Access Compliance Report

Public Rights-of-Way

Intersection ID: 10904	Main Street: ALLEGHANY_ST	Cross Street: ASHLEY_RD	Location:	SE
ADA ID: D2D9974A0117	Ramp Type: PerpDiag	Initial Pass/Fail: Fail	Overall Compliance: No	Severity Score: 12.5
Codes/Mitigation Info/Possible Solution		Field Measurements/Component Compliance

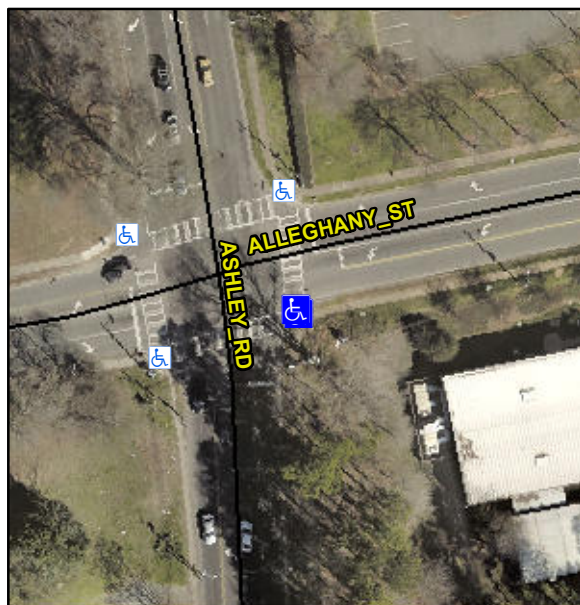
Remove & Replace Curb Ramp With Two New Directional Ramps or Equivalent.

Not Found, R304.2.2

Compliance	Description	Data	Compliance	Description	Data
N/A	Ramp Length (in)	52.0	No	Ramp Slope (%)	9.3
Yes	Ramp Width (in)	48.0	Yes	Ramp XSlope (%)	0.3
N/A	Flare Type LT	N/A	N/A	Flare Type RT	N/A
N/A	Flare Slope LT (%)	N/A	N/A	Flare Slope RT (%)	N/A
N/A	Flare Traversable LT?	N/A	N/A	Flare Traversable RT?	N/A
N/A	Landing Length (in)	N/A	N/A	DWS Provided?	N/A
N/A	Landing Width (in)	N/A	N/A	DWS Contrast?	N/A
N/A	Landing Slope (%)	N/A	N/A	DWS Length (in)	N/A
N/A	Landing X Slope (%)	N/A	N/A	DWS Full Width?	N/A
N/A	Landing Curb? (Y/N)	N/A	N/A	DWS Offset (in)	N/A
N/A	Shared Landing?	N/A			
N/A	Gutter Ponding?	N/A	N/A	Gutter Slope (%)	N/A
N/A	Gutter Lip Ht (in)	N/A	N/A	Gutter X Slope (%)	N/A
N/A	Painted X Walk1?	Yes	N/A	Painted X Walk2?	Yes
	X Walk 1 Direction	To N		X Walk 2 Direction	To W
N/A	X Walk 1 Width (in)	115.0	N/A	X Walk 2 Width (in)	100.0
	X Walk 1 Slope (%)	1.9		X Walk 2 Slope (%)	1.6
	X Walk 1 X Slope (%)	1.1		X Walk 2 X Slope (%)	0.3
